SUBJECT: Provides addl info re proposed license amends re moderator temp coefficient surveillance requirements."

Re: St. Lucie Units 1 and 2
Docket Nos. 50-335 and 50-389
Additional Information on Proposed License Amendments
Moderator Temperature Coefficient Surveillance Requirements
(TAC Nos. 66854 and 66855)

RESPONSE TO CONFERENCE CALL QUESTIONS

Figure 1

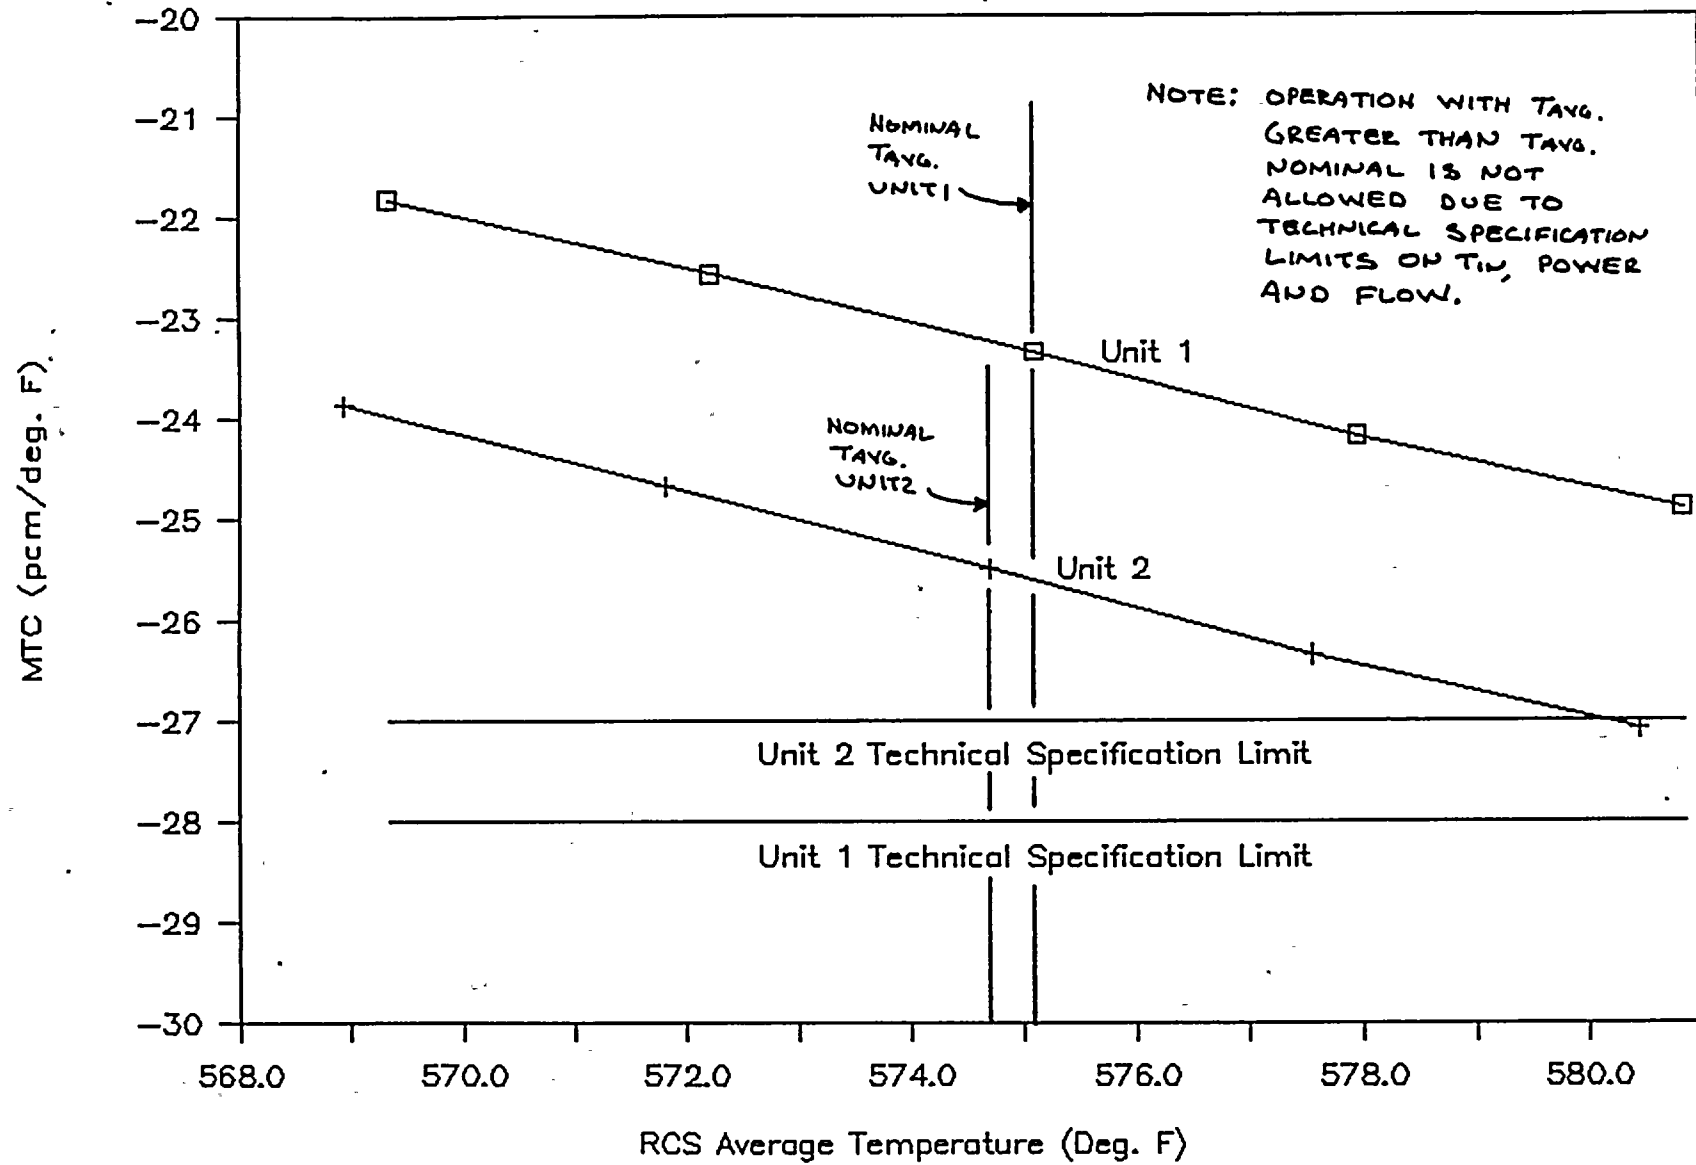
5. Assume that during normal end of cycle (EOC) plant operation, plant conditions such as core average temperature, rod position, reactor coolant pressure, critical boron concentrations, etc., vary so as to change the MTC. Can these plant parameters vary within technical specification limits such that the MTC is more negative than the limit stated in the St. Lucie Technical Specifications?

The results show that the EOC MTC is strongly dependent on the steady state coolant average temperature when all other parameters are held constant. Figure 1 shows this dependency. The dependency was found to be -0.29 pcm/degree F per degree F for Unit 1 and -0.28 pcm/degree F per degree F for Unit 2. For example, a 10 degree F increase in the average coolant temperature will lead to a 2.9 pcm/degree F decrease in the EOC MTC for Unit 1 and a 2.8 pcm/degree F decrease in the EOC MTC for Unit 2.
